Your Ref
Y/79/18/HH
Our Ref
PLAN-025492
Date
06/12/2018

Proposal: Conversion of attached garage and replacement extension.
Site: 21 Downview Road, Yapton, BN18 0HL.
Y/79/18/HH

Due to surface water inundation issues in the Lidsey Catchment "The applicant is advised to adopt, where appropriate, the measures in the table "Practical measures to reduce the potential impacts of development".

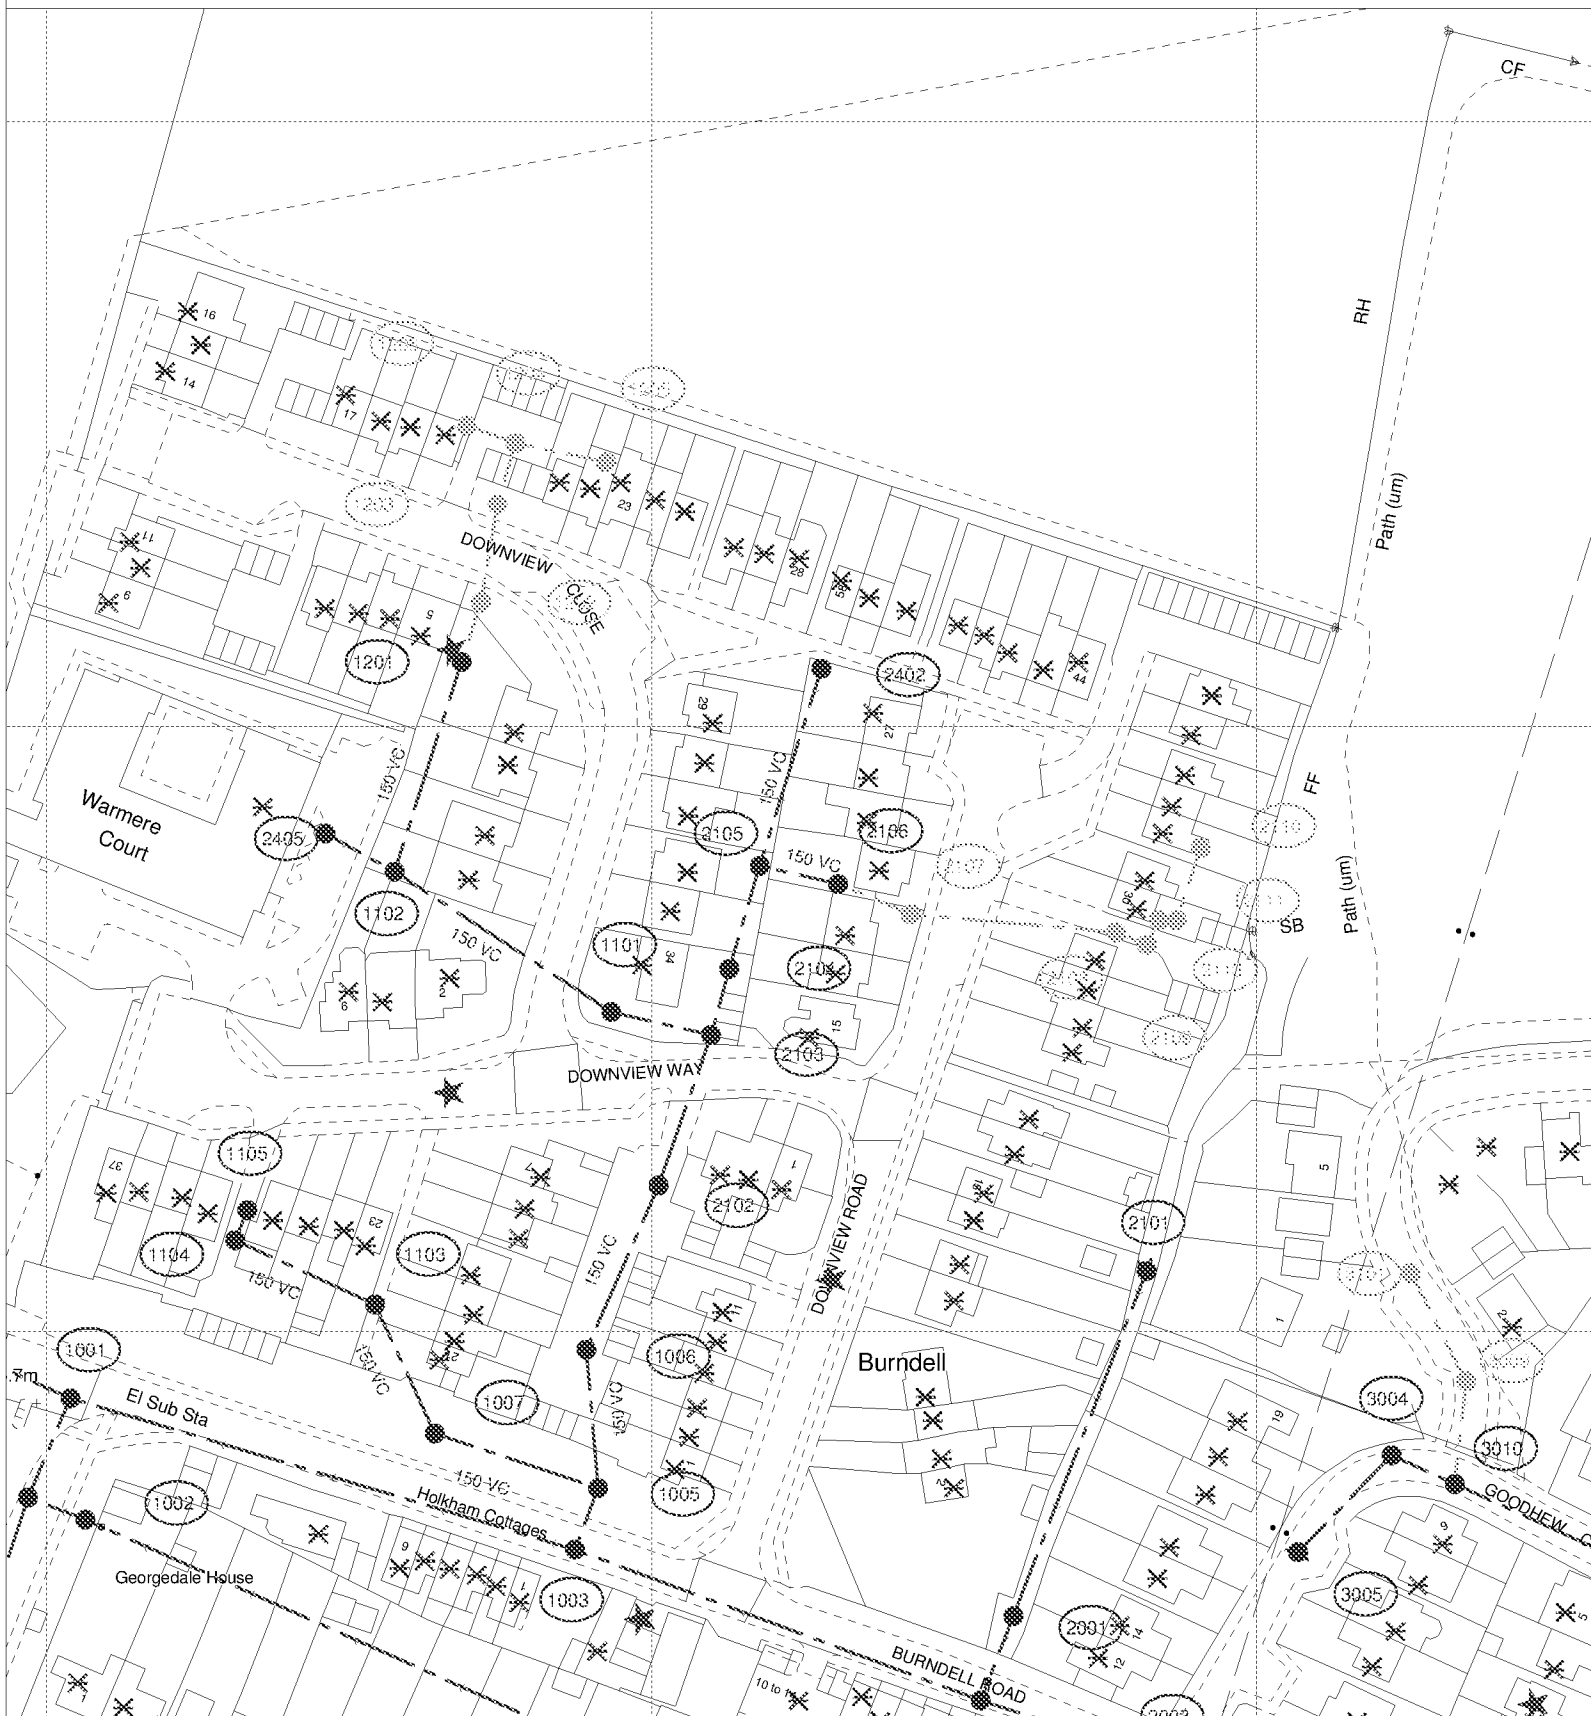
Developer should look to protect the public sewerage system from inundation and infiltration, which contribute to flooding in unfavourable conditions.
